ST10F271B/E, ST10F272B/E Errata sheet

BAG silicon version

This errata sheet describes all the functional and electrical problems known in the BAG silicon version of ST10F271B, ST10F271E, ST10F272B and ST10F272E microcontrollers (MCUs).

Figure 1. ST10 in Slave mode

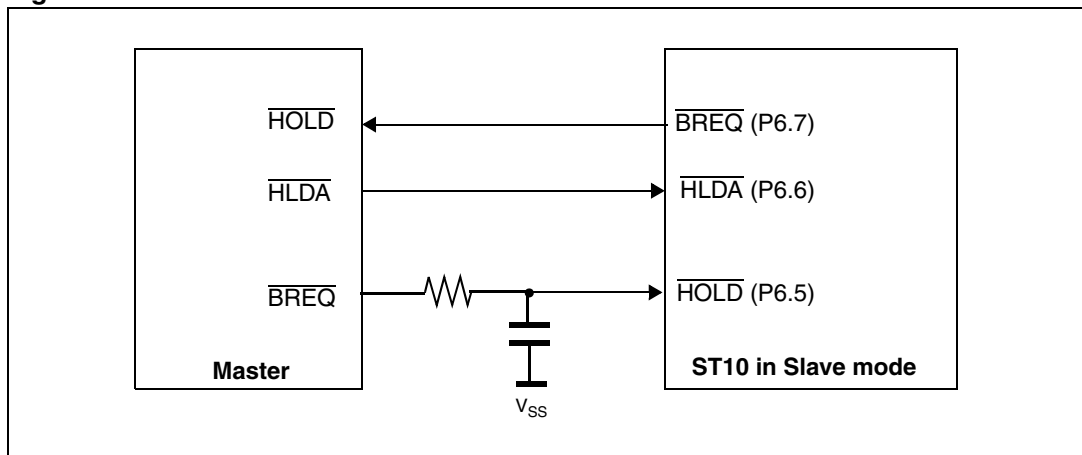
BUS.9 Spurious BREQ pulse in slave mode during external bus arbitration phase

Description: When using external bus arbitration via the HOLD function with the ST10F271B/E - ST10F272B/E configured as a slave, sporadic bus errors may occur.

After the slave has been granted the bus, the slave deactivates BREQ sporadically for a short time, even though the bus access of the slave has not been completed. The master then starts its own bus access, leading to a bus conflict between master and slave.

Workaround: In order not to produce any spurious BREQ pulse during a Slave External Bus Arbitration Phase, it is necessary to guarantee that the time between the HOLDA assertion (Bus Acknowledge from Master device) and the following HOLD falling edge (Bus Request from Master) is greater than three clock cycles.

This can be implemented by delaying the HOLD signal with an RC circuit as shown in [Figure 1](#).
